# ADDENDUM NO. 05

Date of Issuance: January 30, 2025  
Project: **2024 Cypress Falls HS Renovation**  
Cypress-Fairbanks Independent School District

Texas Arcadis Inc.  
Project No.: 202318

3 AREA 'B' ROOF  
UPLIFT KEY MAP  
SCALE: 1/8" = 1'-0"

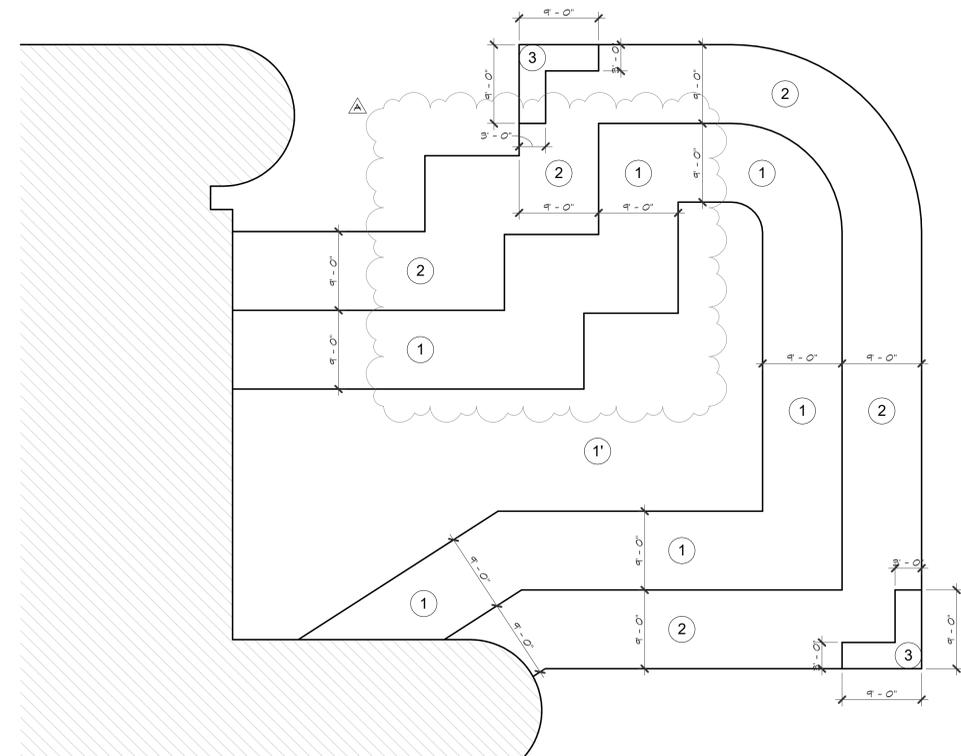
14. Sheet S0.05 – Uplift Key Maps
  - a. Change Area ‘B’ roof uplift key map plan to match building addition extents
  - b. Change Area ‘A’ roof uplift key map plan to match building addition extents

**AREA "D" DEMO FOUNDATION PLAN**  
 SCALE: 1/8" = 1'-0"

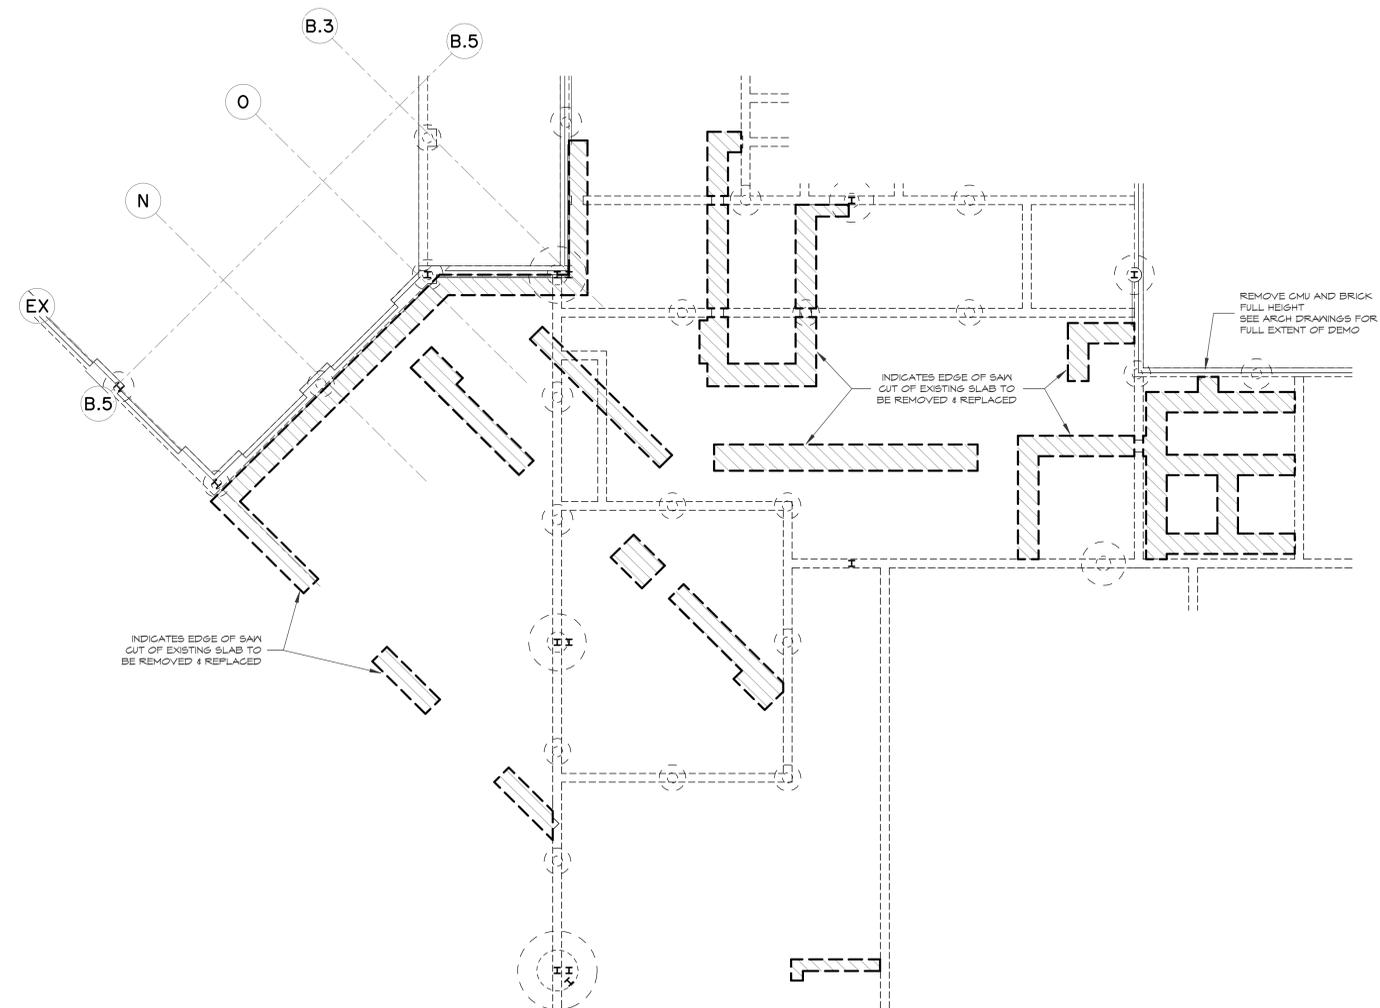
15. Sheet SD1.01 – Foundation Demo Plans
  - a. Update area ‘D’ demo plan to show new shovel beam under new CMU walls in room D128
16. Sheet SD1.02 – Foundation Demo Plans

**GREENHOUSE FOUNDATION PLAN**  
SCALE: 1/8" = 1'-0"

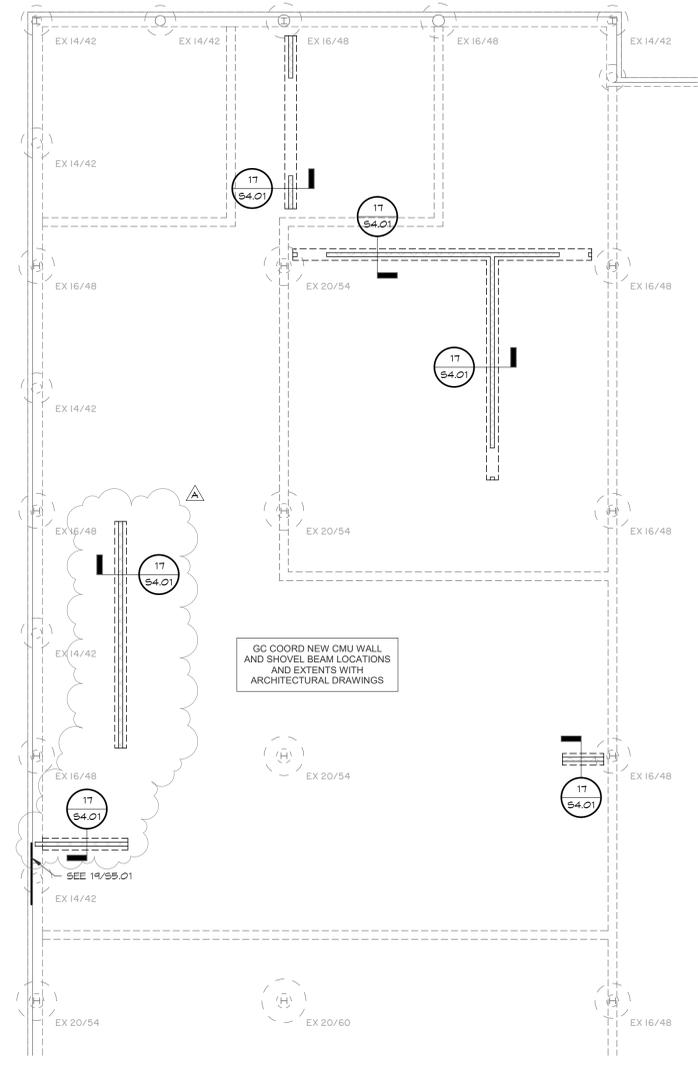
- a. Change dimensions of the out-to-out of the greenhouse to match architectural drawings
  - b. Change brick ledge locations at greenhouse to match architectural drawings

**AREA "D" FOUNDATION PLAN**  
SCALE: 1/8" = 1'-0"

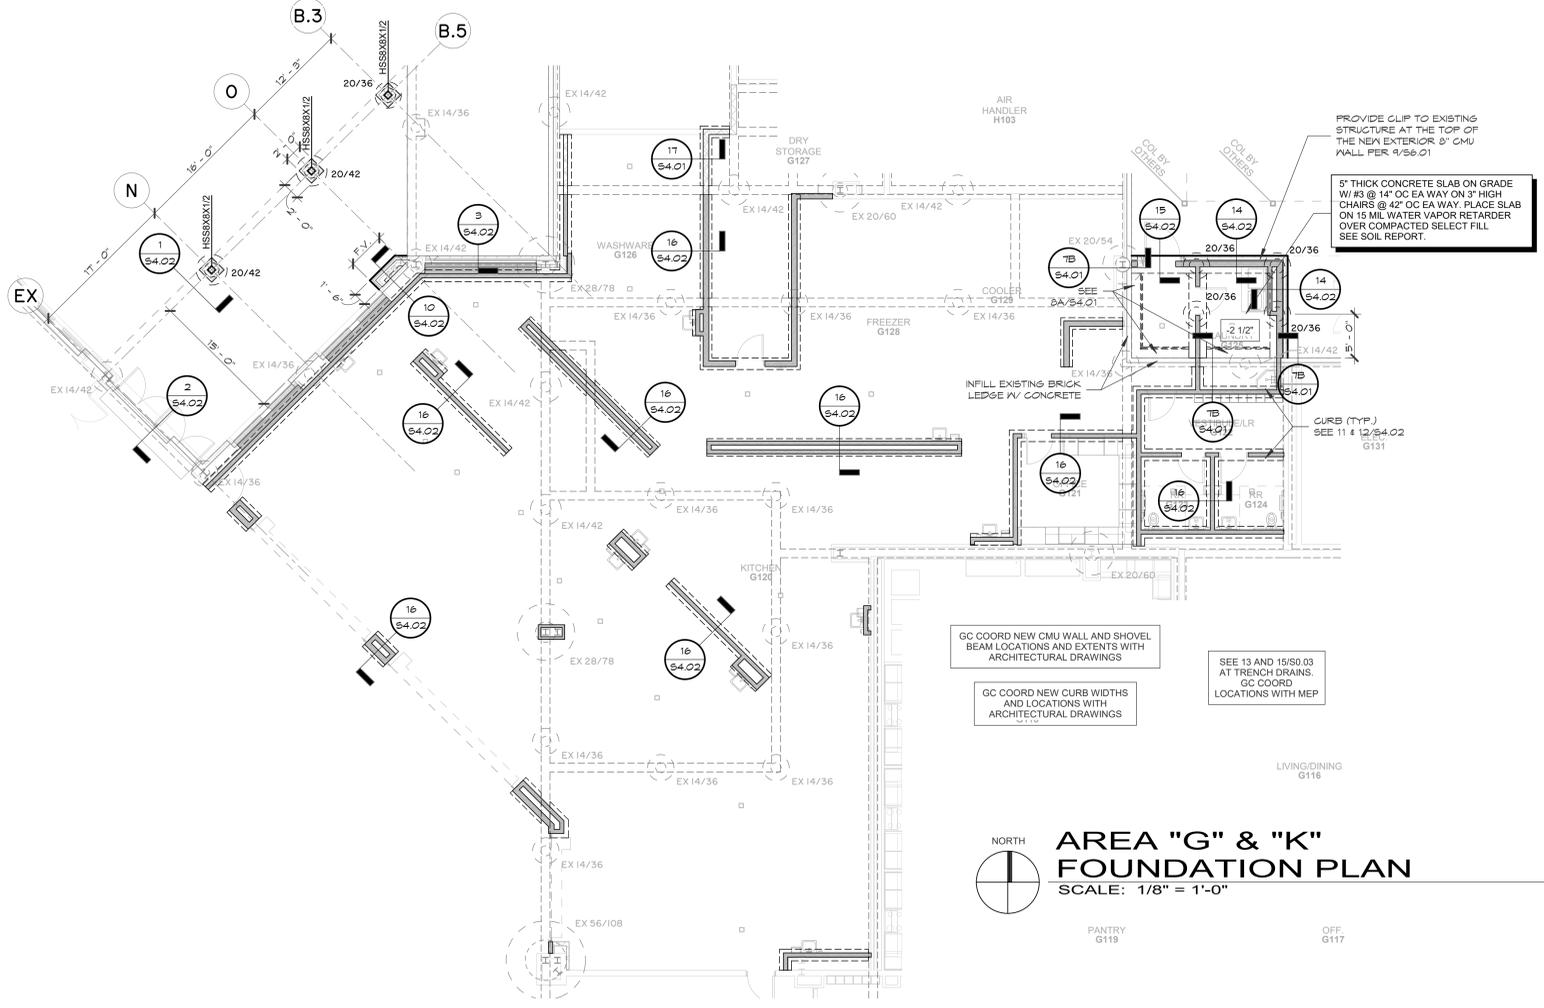
- c. Show shovel beam under new CMU walls in room D128 in the Area “D” foundation plan
19. Sheet A0.04 – AREA ‘D’ – 1<sup>ST</sup> FLOOR DEMO PLAN
- a. Add ceiling demo scope marked by demo keynote 42.

**E0.03**  
 ELECTRICAL  
 DEMOLITION 1ST  
 FLOOR PLAN - AREA  
 'D'

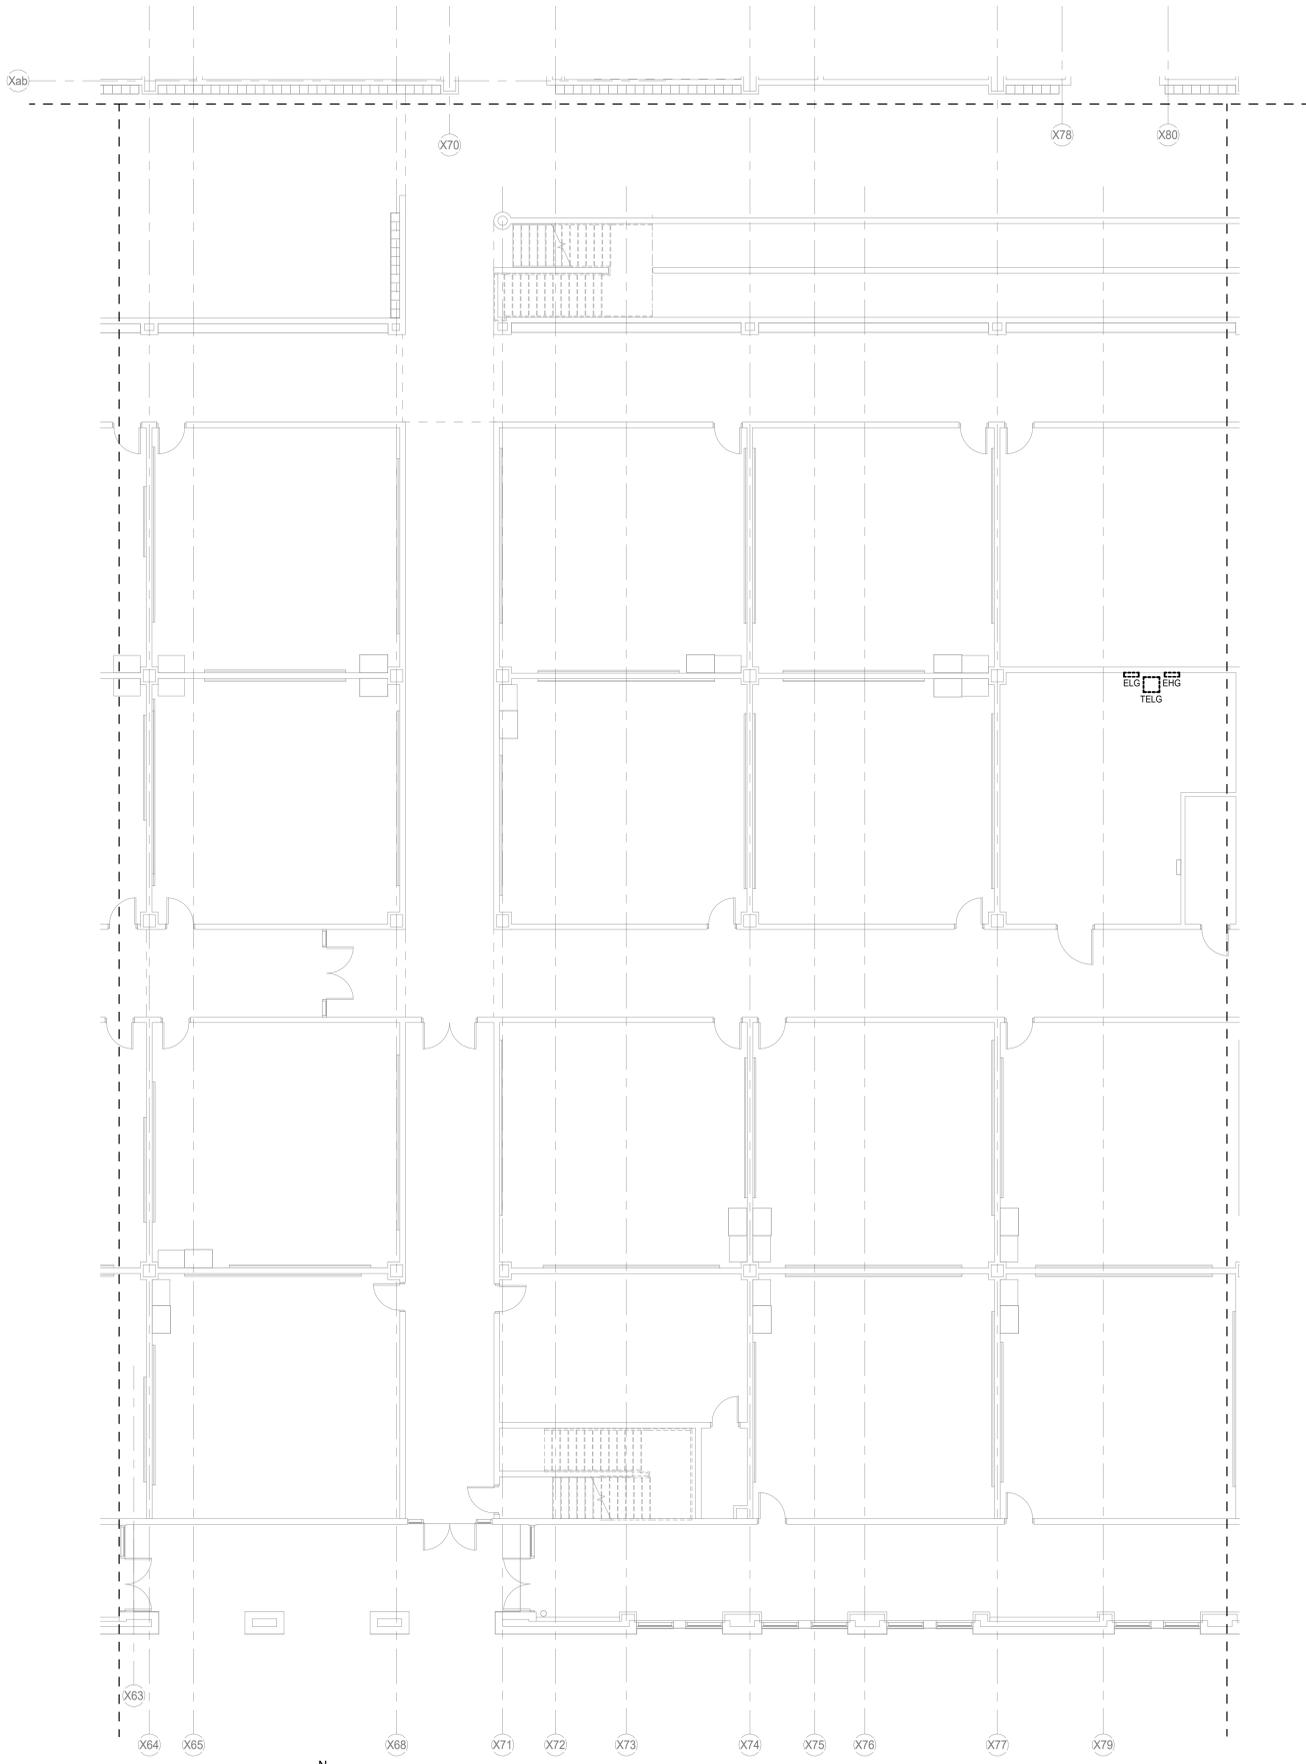
53. Sheet E0.02 - ELECTRICAL DEMOLITION 1ST FLOOR PLAN - AREA 'B'  
a. Refer to revised sheet.
54. Sheet E0.03 - ELECTRICAL DEMOLITION 1ST FLOOR PLAN - AREA 'D'

a. Refer to revised sheet.
55. Sheet E0.04 - ELECTRICAL DEMOLITION 1ST FLOOR PLAN - AREA 'E'  
a. Refer to revised sheet.
56. Sheet E0.05 - ELECTRICAL DEMOLITION 1ST FLOOR PLAN - AREA 'G'

**E1.03**  
ELECTRICAL ENLARGED SITE PLANS - PRESSBOXES

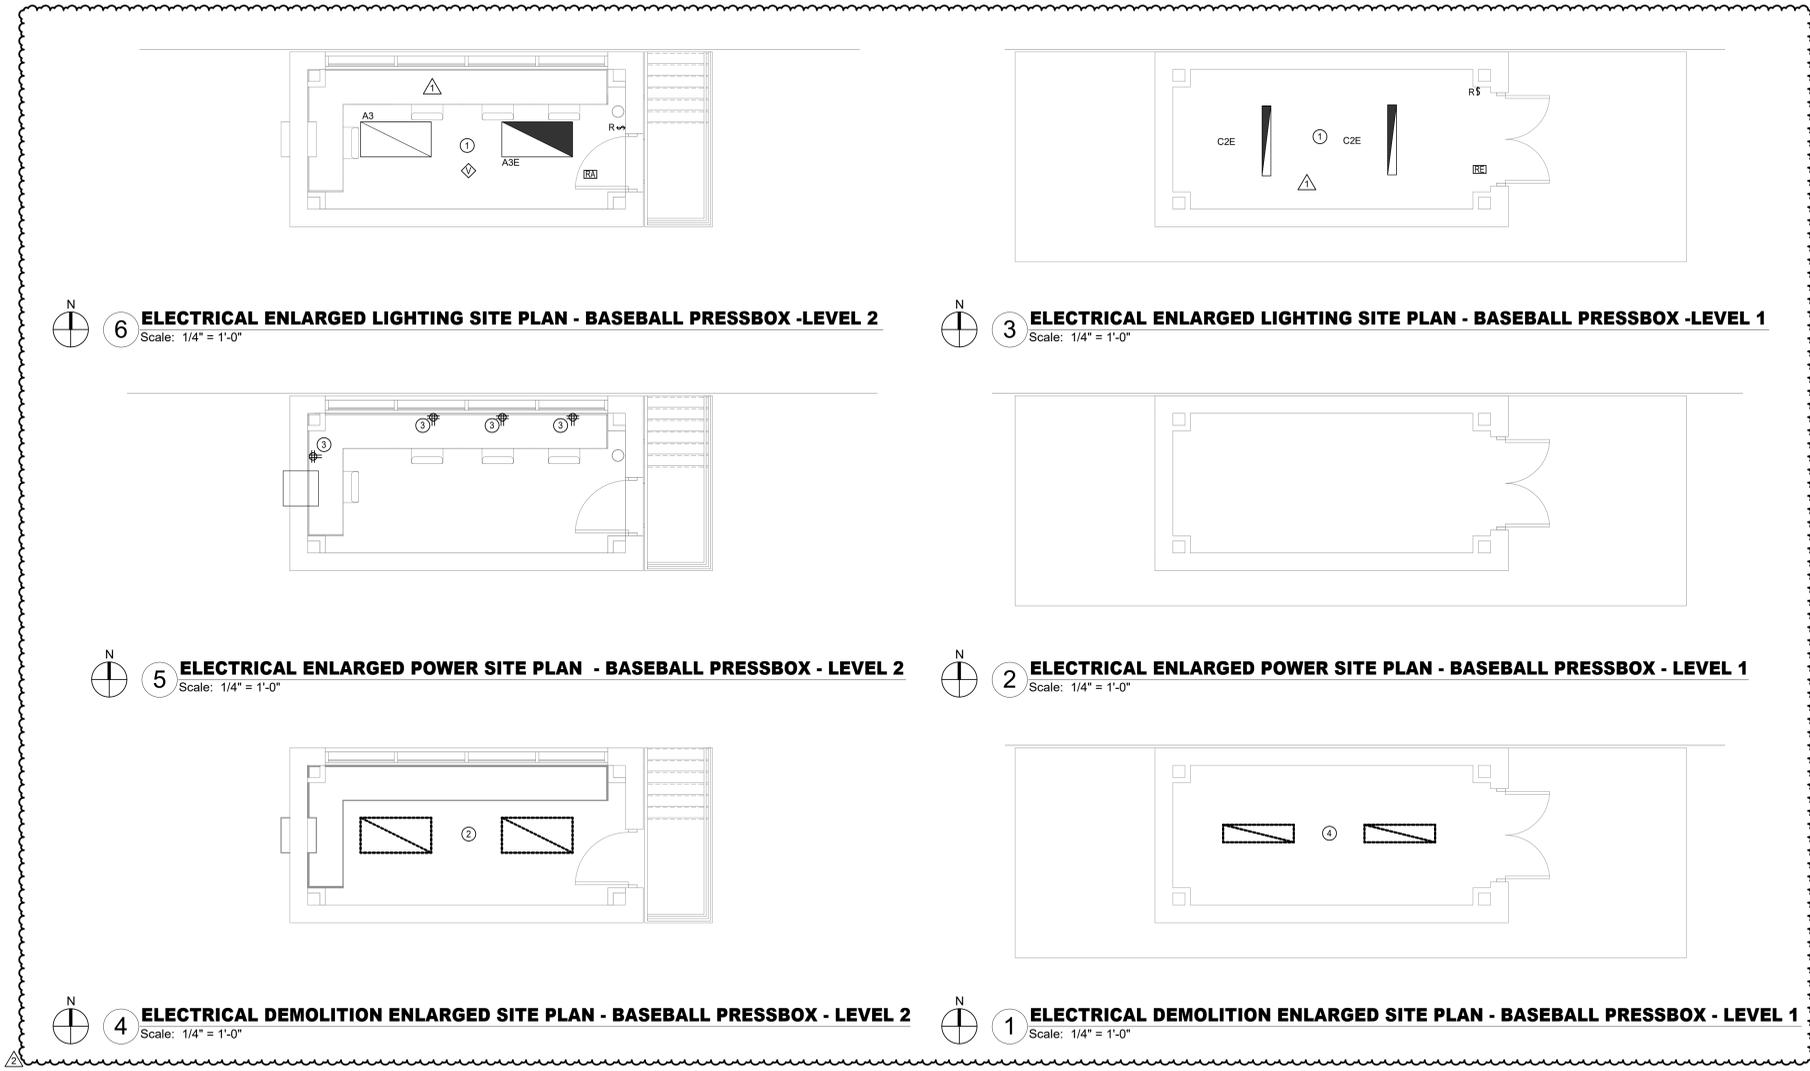
a. Refer to revised sheet.
64. Sheet E0.13 - ELECTRICAL DEMOLITION 2ND FLOOR PLAN - AREA 'U'  
a. Refer to revised sheet.
65. Sheet E1.03 - ELECTRICAL ENLARGED SITE PLANS – PRESSBOXES

a. Refer to revised sheet.
66. Sheet E1.04 - ELECTRICAL ENLARGED SITE PLANS - PRESSBOXES  
a. Refer to revised sheet.
67. Sheet E2.01 - ELECTRICAL 1ST FLOOR COMPOSITE FLOOR PLAN
